APPLICATION NO.	FILING DATE	FIRST NAMED INVENTOR	ATTORNEY DOCKET NO.	CONFIRMATION NO.
10/708,515	03/09/2004	Ronald L. Gordon	FIS920030380	2514
29505 7590 10/16/2007 LAW OFFICE OF DELIO & PETERSON, LLC. 121 WHITNEY AVENUE NEW HAVEN, CT 06510			EXAMINER RASHID, DAVID	
			ART UNIT 2624	PAPER NUMBER
			MAIL DATE 10/16/2007	DELIVERY MODE PAPER

Office Action Summary

DETAILED ACTION

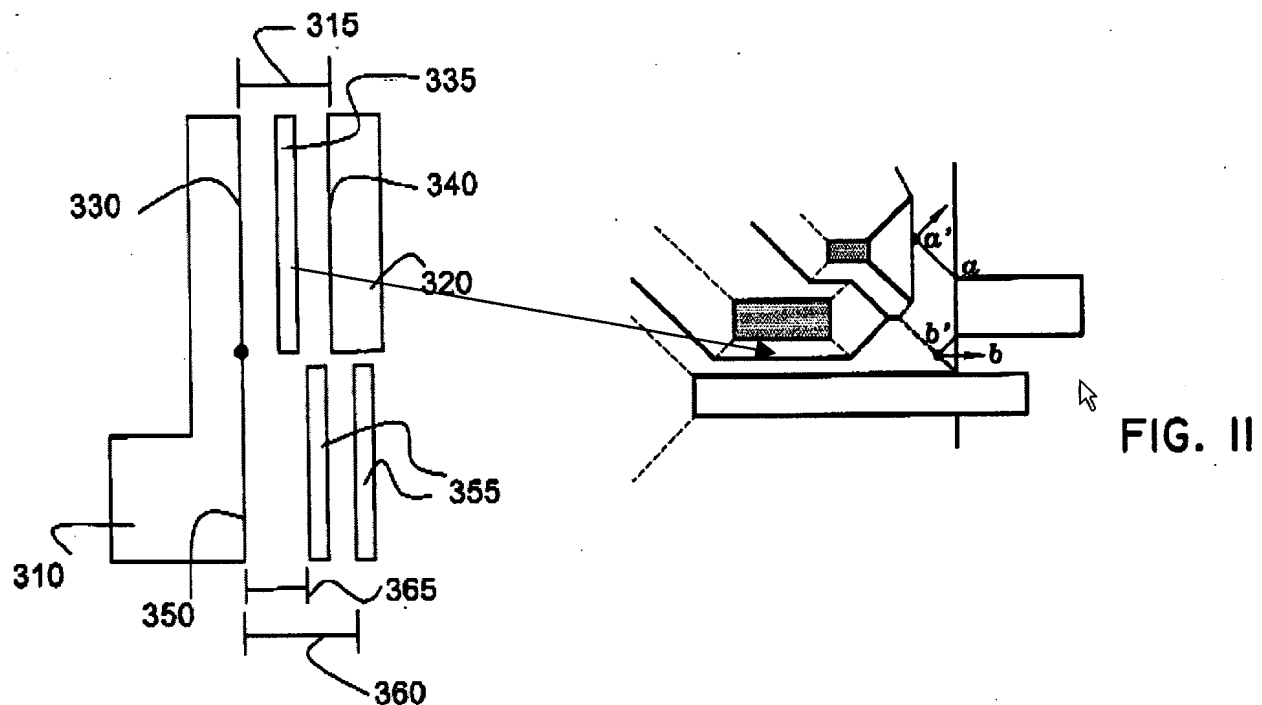
Papadopoulou is a method that creates Voronoi cells around spaced integrated circuit shapes (FIG. 5; FIG. 11, Papadopoulou), which includes determining bisectors (the bold lines of FIG. 5; FIG. 4 arrow, Papadopoulou) between adjacent ones of the spaced integrated circuit shapes, the bisectors comprising locus of points equidistant (Col. 5, line 66 – Col. 6, line 2, Papadopoulou) from edges of the adjacent spaced integrated circuit shapes and defining shared boundaries (defining the shared boundary is the bold bisector line/arrow itself in FIG. 4, FIG. 5, and so forth, Papadopoulou) of adjacent Voronoi cells.

FIG. 11 of Papadopoulou (though FIG. 5 is equally applicable) provides fairly straightforward reasoning why it would have been obvious to one of ordinary skill in the art at the time the invention was made for the bisector and SRAF placement of Robles to use Voronoi cells and bisectors from the Voronoi algorithm of Papadopoulou. Robles in determining its bisector and SRAF placement could use the Voronoi algorithm of Papadopoulou to achieve the same results for any parallel partition between two edges as evident in FIG. 11 of Papadopoulou and FIG. 3 of Robles.
